**PUBLIC MEETING TO DISCUSS THE UNISTAR
TOPICAL REPORT FOR THE USE OF HIGH-
DENSITY POLYETHYLENE (HDPE) PIPE,
UN-TR-10-001-NP**

Results of NRC Staff's Acceptance Review of UniStar HDPE Topical Report

Criterion C Issues

TECHNICAL ISSUES (CONT.)

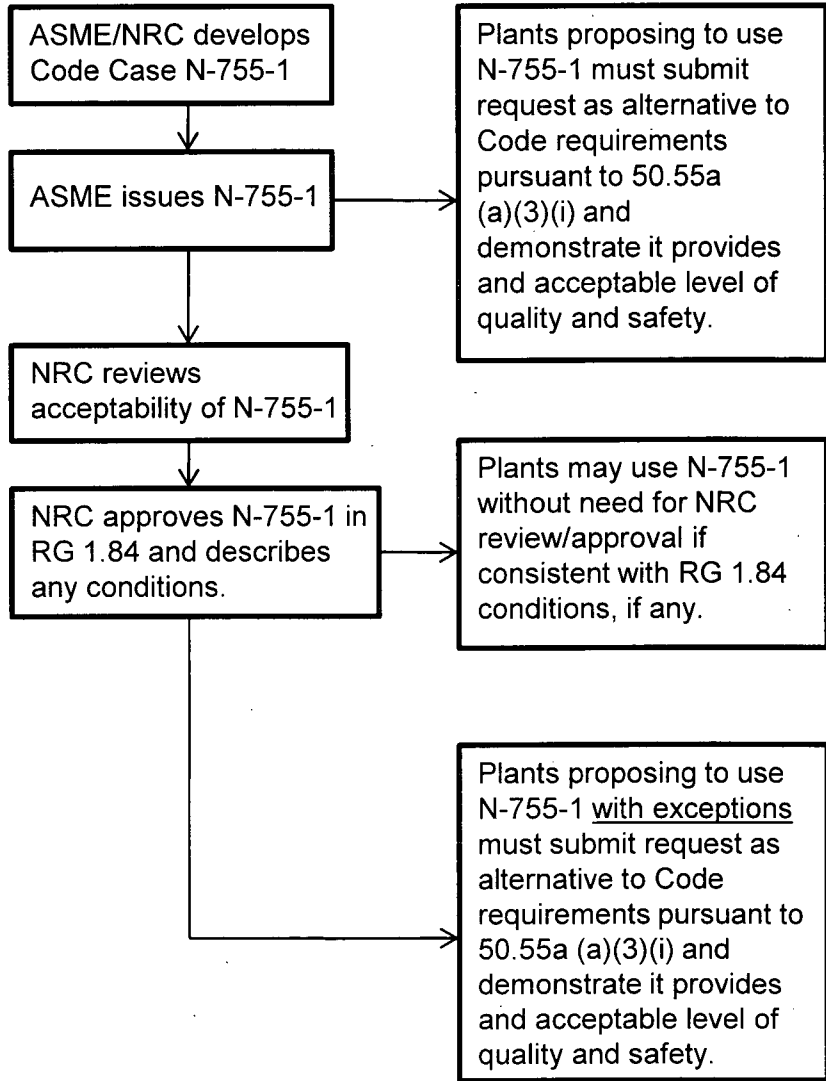
- Section 8.7.3: B-7 discusses bead size for different size pipe. Basis has not been provided to justify bead sizes are adequate. Testing is being performed to verify this variable by PPI.
- Section 8.7.3: D1 states that 8" DR 11 pipe size will be minimum pipe size for qualification of butt fusion joint. No basis or test data has been received to justify this requirement. NRC has stated that each diameter and material thickness is considered an essential variable and needs to be qualified.
- Section 8.8.3: A-1 states that one of the successful retests shall be used for mechanical testing. Test data has confirmed that areas of a pipe that passed UT failed tensile specimens by brittle failure, and pipe that failed UT passed tensile specimens.
- Section 8.8.4: A-1 specifies a range of pipe diameter. There is no test data or basis to support these ranges.
